US 50 / South Shore Community Revitalization Project

Final
Environmental Impact Report/
Environmental Impact Statement/
Environmental Impact Statement

October 2018

US 50/South Shore Community Revitalization Project
Final Environmental Impact Report/Environmental Impact Statement/Environmental Impact Statement (EIR/EIS/EIS) and Section 4(f) *De Minimis* Determination

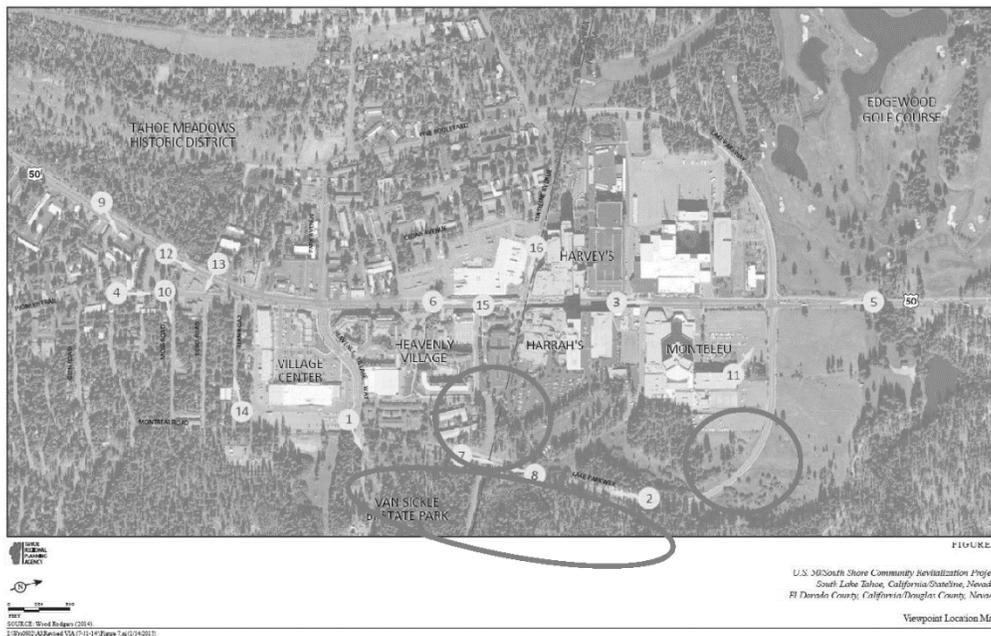
notes a *decrease* in visual quality associated with the limited viewpoints that were analyzed in these areas, yet the protection of natural scenic resources should be prioritized above improvements to the urban areas.

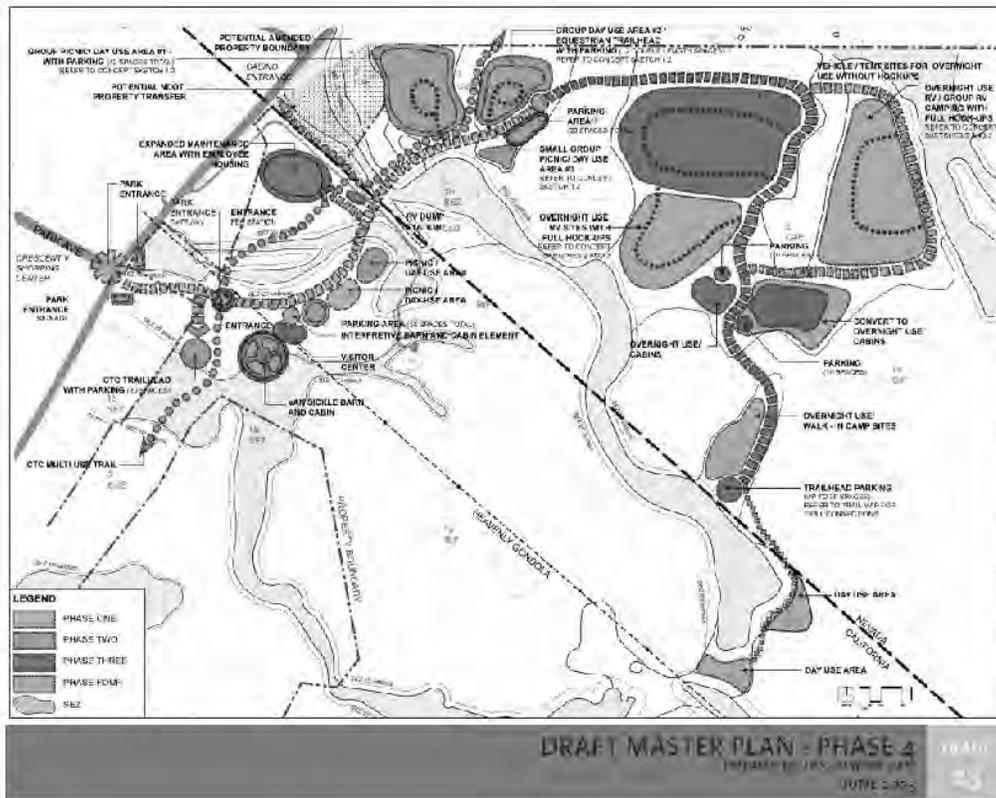
There are far more viewpoints selected in the urban areas than the natural areas where emphasis should be placed.

For example, the EIR/S/S should include the following viewpoints (the recommended general vicinity is identified with red circles in figures above and below):

The commenter suggests that there are far more viewpoints selected for analysis in the urban areas than the natural areas where emphasis should be placed. The comment includes an excerpt with Figure 7 from the Visual Impact Assessment (VIA) included in Appendix G of the Draft EIR/EIS/EIS, with circled viewpoints that should be included.

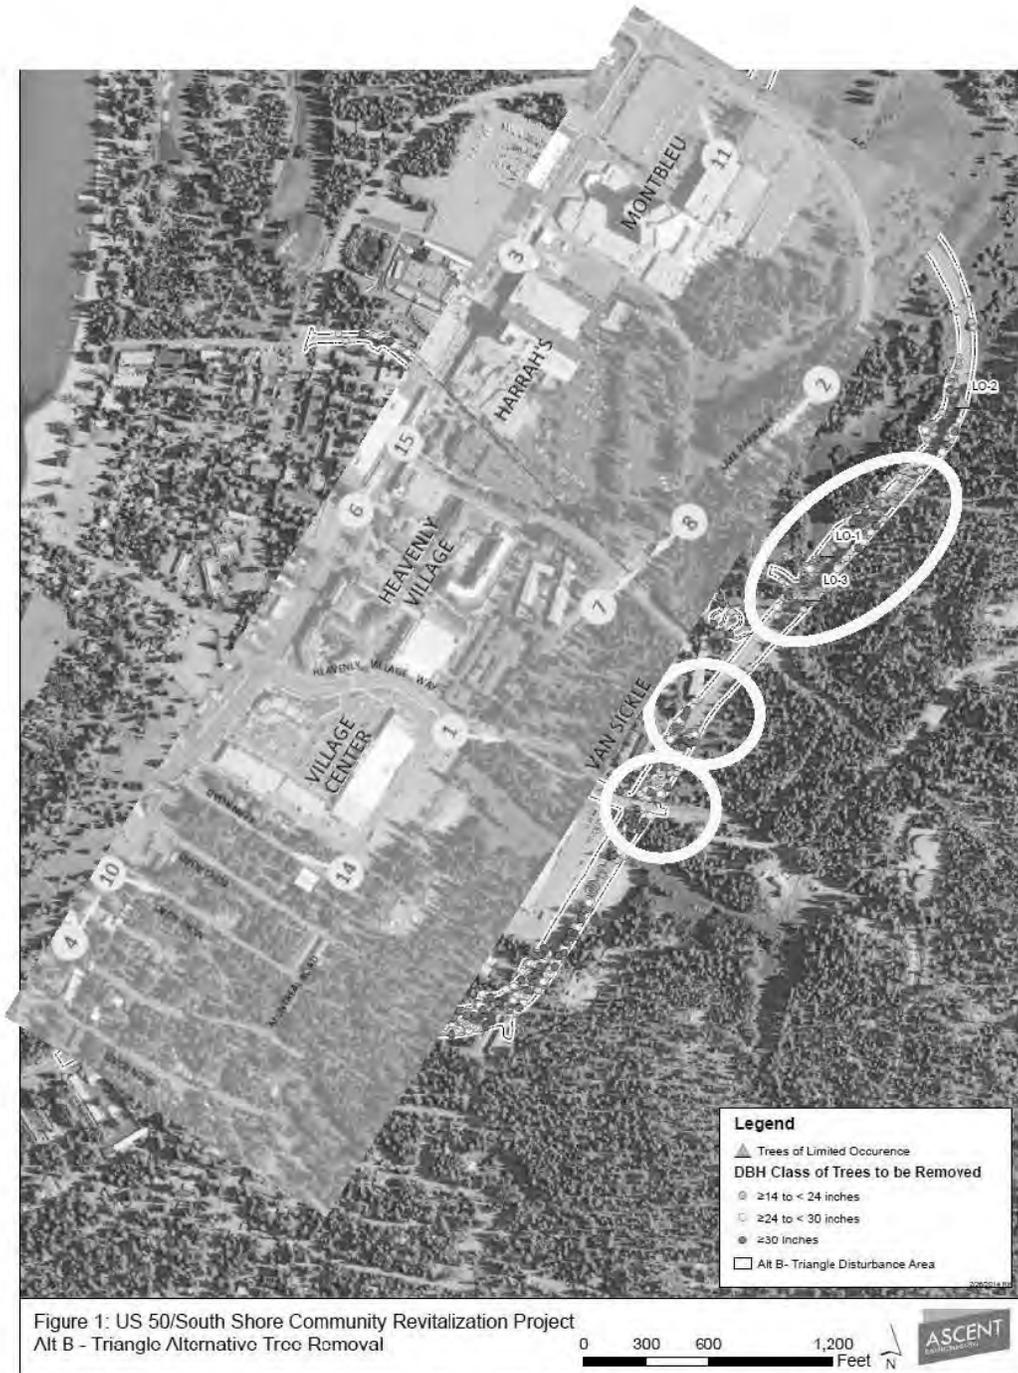
Image above compares a section of App. G's "Viewpoint Location Map" with the tree removal required for Alt. B (App. L). The hollow yellow circles show the general vicinity of viewpoint areas that will be impacted by tree removal.

12-54 The commenter contends that the viewpoint simulations along Lake Parkway do not appear to reflect the removal of trees. The commenter has compared trees marked for removal in Figure 1 in Appendix L of the Draft EIR/EIS/EIS with three visual simulations from the VIA (Appendix G of the Draft EIR/EIS/EIS). As described in Response to Comment 12-45, the VIA was prepared before the development of various design elements and context-sensitive aesthetic treatments that are incorporated into the realignment alternatives. The context-sensitive are shown in Exhibits 3.7-7, 3.7-8, and 3.7-9 of the Draft EIR/EIS/EIS. The viewpoint locations depicted in these exhibits are similar to those referenced in this comment. Because the commenter focused on visual simulations that have been superseded and the commenter does not identify any concerns related to the simulations included in Section 3.7, "Visual Resources/Aesthetics," of the Draft EIR/EIS/EIS, for which impact determinations were made, no further analysis is needed.
